Re: St. Lucie Unit 1
Docket No. 50-335
Revised Steam Generator Tube Inservice Inspection
Special Report for Refueling Outage SL1-19 & RAI Response

**Replacement St. Lucie Unit 1
Spring 2004 Refueling Outage SL1-19
Steam Generator Tube Inservice Inspection
Special Report**

**REQUEST FOR ADDITIONAL INFORMATION
SL1-19 STEAM GENERATOR TUBE INSERVICE INSPECTION SPECIAL REPORT
ST. LUCIE NUCLEAR PLANT, UNIT 1
DOCKET NUMBER 50-335**

FIGURE 1
PSL-1 Replacement Steam Generator Support Identification

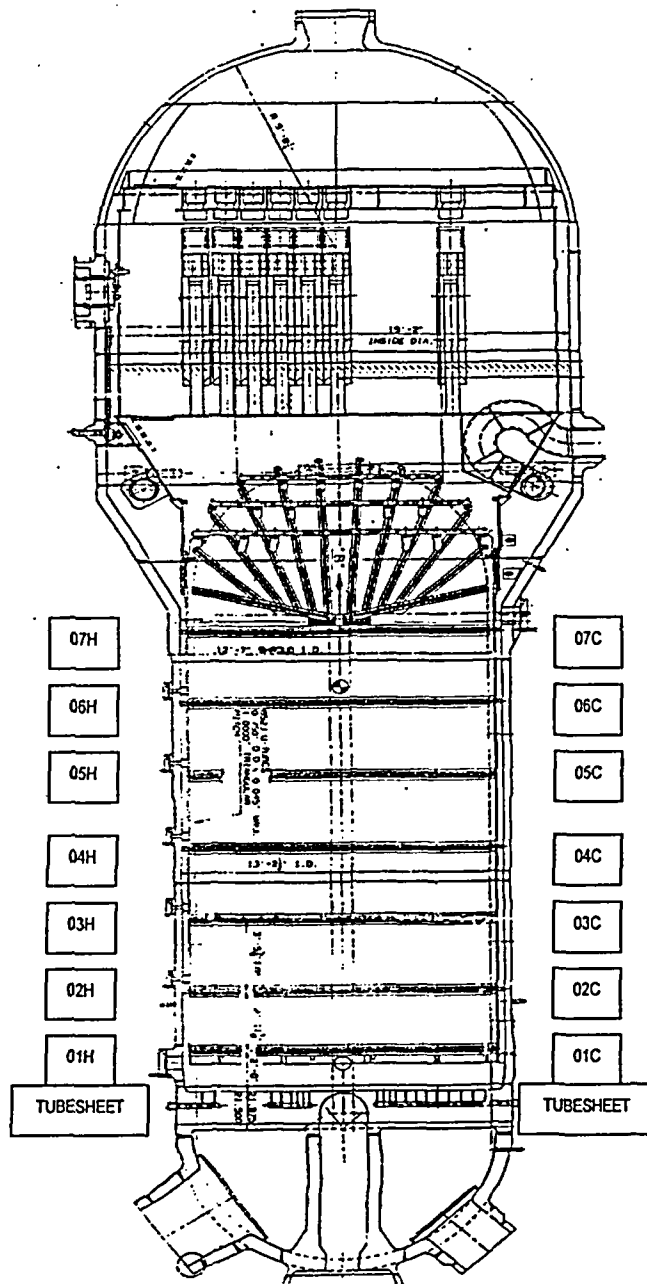
There is limited steam generator design information in the St. Lucie Updated Final Safety Analysis Report. In order for the staff to better understand the design of your steam generators and the location of the indications described in your reports, please provide the following design information for St. Lucie Unit 1: (a) the manufacturer's model number for the replacement steam generators, (b) tube manufacturer, (c) outer diameter and nominal wall thickness of tubes, (d) number of tubes in each steam generator, (e) tube pitch and pattern (e.g., 0.95 inches triangular), (f) tubesheet thickness (with and without clad), (g) a sketch depicting the tube support structure naming (h) anti-vibration bar (fan bar) design, (i) tube support material (e.g., 410 Stainless Steel), (j) a sketch of a tubesheet map which depicts the rows and columns of the tubes in the steam generators, (k) smallest U-bend radius in the steam generator and the radii of the row 1 tubes, (l) stress relief after bending of tubes (e.g., stress relief of the entire tube length for the tubes in rows 1 through 27).

(e) tube pitch and pattern (e.g., 0.95 inches triangular)	1.0 inch triangular
(f) tubesheet thickness (with/without clad)	21.875 inches / 21.50 inches
(g) a sketch depicting the tube support structure naming	See Figure 1
